RE: Adequacy Questions 2, DRMS AM-4 application – Home Office Mine, Permit M1977-439

RE: Adequacy Review 2 follow-up, DRMS AM-4 application – Home Office Mine, Permit M1977-439

EXHIBIT G: WATER INFORMATION

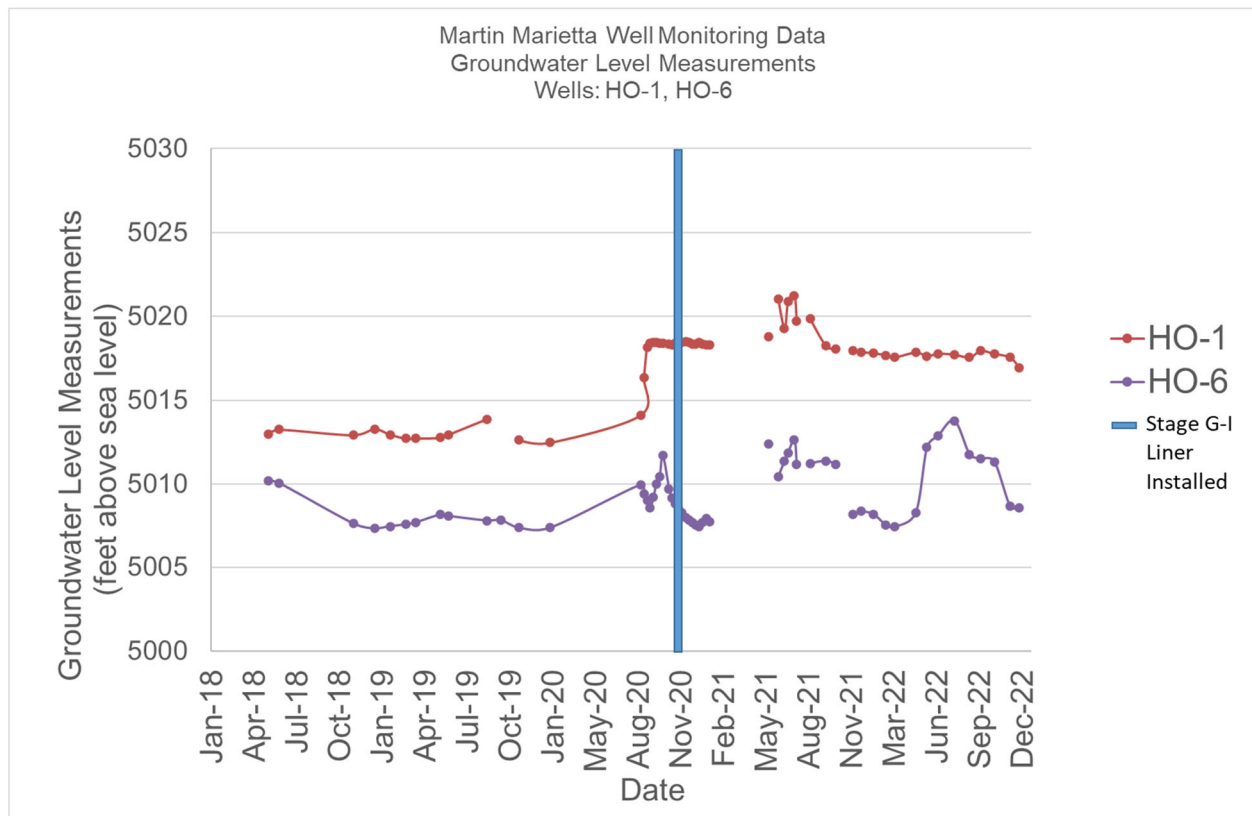
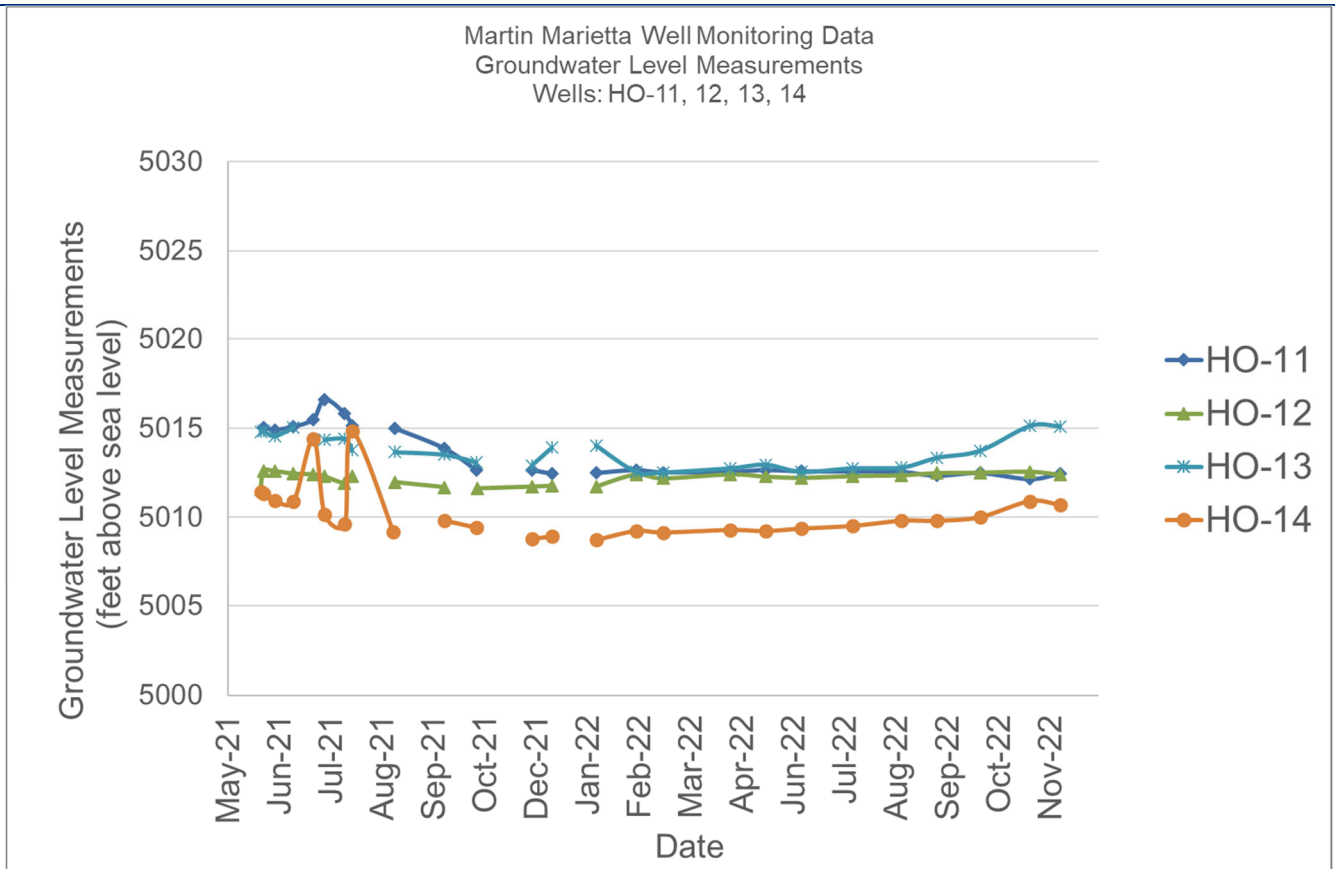
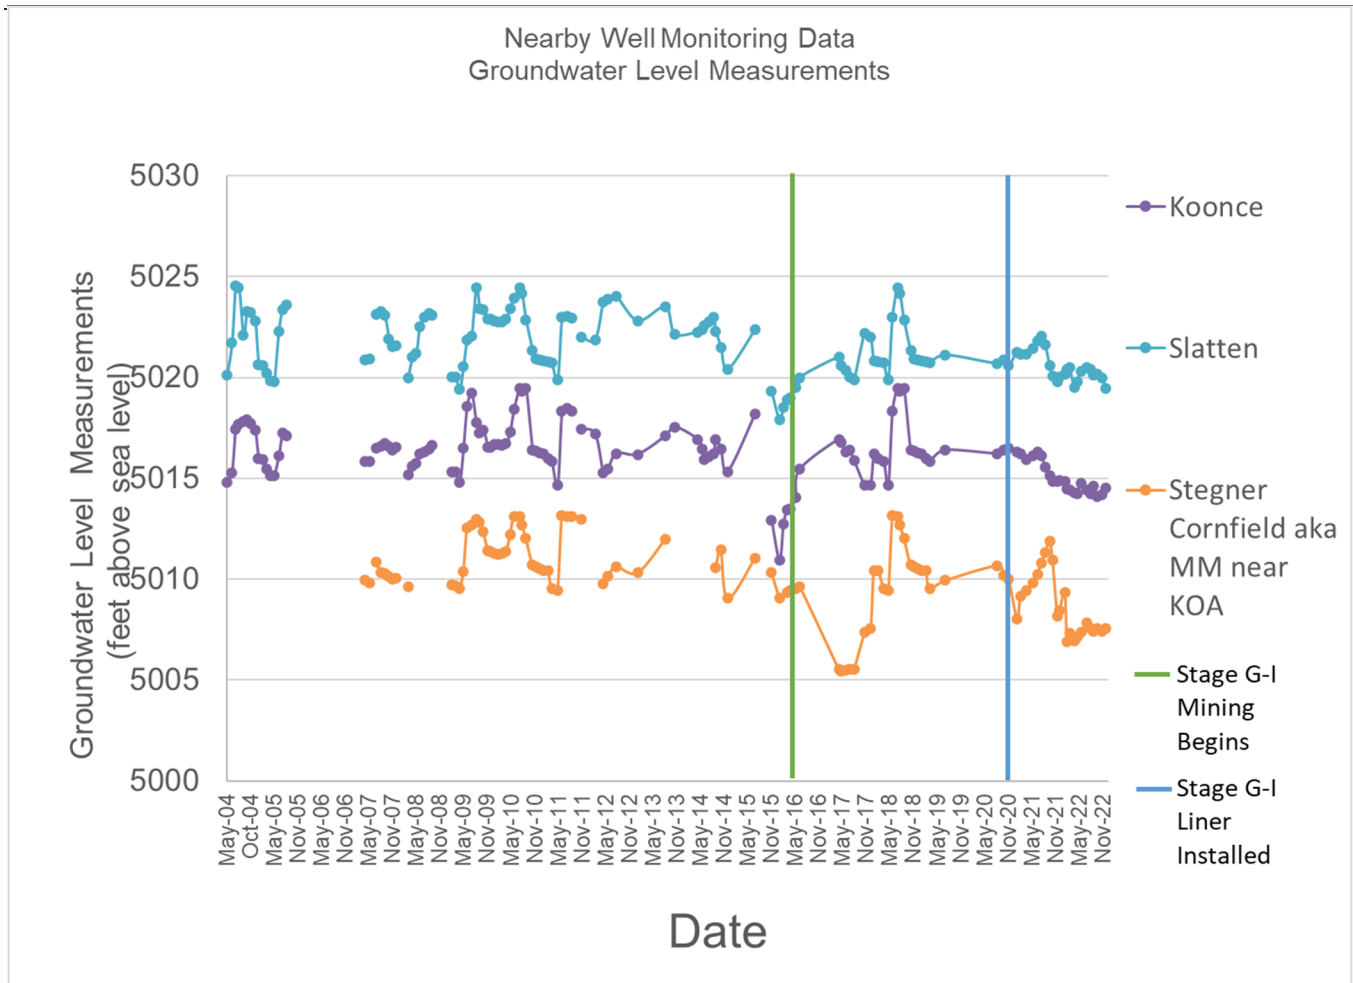
- f. Due to the mounding impacts already observed and at least partly mitigated along the west side of phase G1, the permittee should provide advance designs for additional underdrains that could be installed if excessive groundwater mounding is observed on the north side of G1 and/or the west side of G2. These additional underdrains could then be rapidly installed (to commence within no more than 30 days) if excessive mounding is identified in these areas during monthly monitoring. Trigger levels may be identified (for example, GW rising to within 3' of the ground surface, or other adverse mounding impacts observed) to trigger implementation of additional corrective actions such as underdrain installation.

- g. Some discussion should be provided to justify the depths of the underdrains, both installed and proposed.

Charts 2, 3 and 6 of Exhibit G (Attachment A to this letter) have all been updated. They present the ground water level data along the north edge of Phase G1. The ground surface along the north edge of Phase G1 is approximately 5025 feet. The highest ground water elevation after the installation of the liner in November of 2020, is approximately 5021 feet in the northwest corner of Phase G1 (see Chart 2 well HO-1 in Attachment A). The highest water elevation in the northeast corner of the reservoir is approximately 5017 feet (see Chart 3 Well HO-11 in Attachment A). The data indicate that the depth to water is approximately four feet after liner installation; therefore, Martin Marietta believes that a drain is not necessary at this location. However,

in the unlikely event that flooding is due to ground water mounding along the north side of Phase G1, Martin Marietta will install an underdrain.
